DEVELOPMENT APPLICATION ASSESSMENT REPORT

Application Number:	DA2022/0761
----------------------------	-------------

Responsible Officer:	Thomas Burns
Land to be developed (Address):	Lot 15 DP 240297, 3 Briony Place MONA VALE NSW 2103
Proposed Development:	Alterations and additions to a dwelling house
Zoning:	C4 Environmental Living
Development Permissible:	Yes
Existing Use Rights:	No
Consent Authority:	Northern Beaches Council
Land and Environment Court Action:	No
Owner:	Janice McColm Robert Brian McColm
Applicant:	Andy's Home Design & Co Pty Ltd

Figure 1: southern elevation side building envelope non-compliance

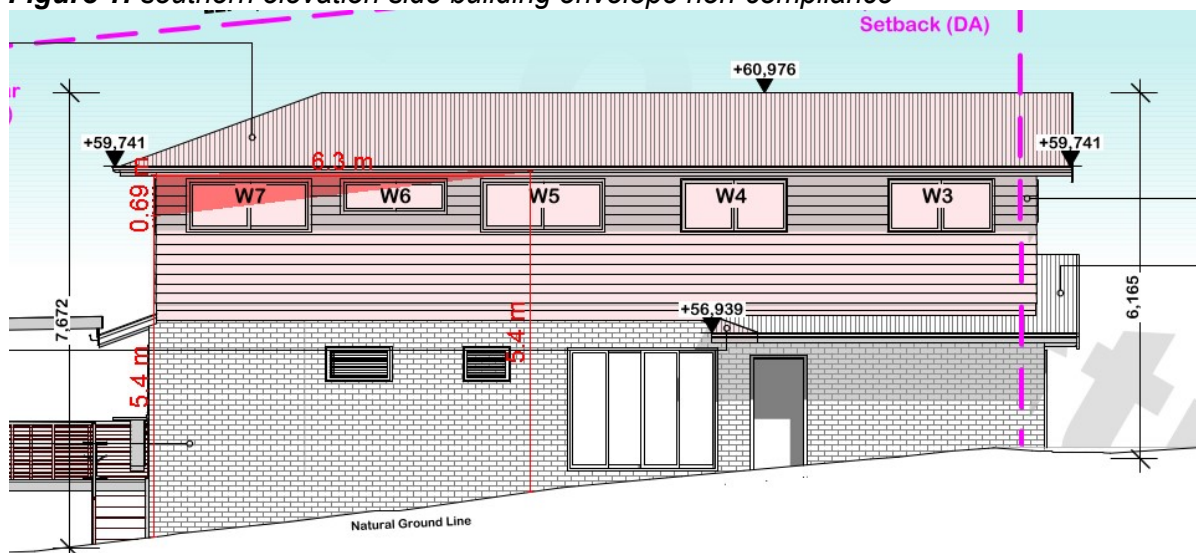
The first floor addition protrudes outside of the prescribed side building envelope on the southern elevation. The breach occurs for a horizontal length of 6.3m to a maximum height of 0.69m. Figure 1 below depicts the extent of the numeric non-compliance

The overall height, bulk and scale of the built form is commensurate with surrounding low density residential development. Thus, it is considered that the bulk and scale of the built form has been minimised, notwithstanding the numeric non-compliance with the side building envelope provision.

Noting that the southern adjacent site adjoins a public reserve, the first floor addition will not result in overshadowing of adjoining residential properties. Furthermore, adequate separation has been provided from the northern and western boundaries, which will ensure that a reasonable level of visual and acoustical privacy is maintained between dwellings. Overall, the proposal satisfies this outcome.

Having regard to the above assessment, it is concluded that the outcomes of the control have been achieved. Therefore, the application is supported on merit in this particular circumstance.
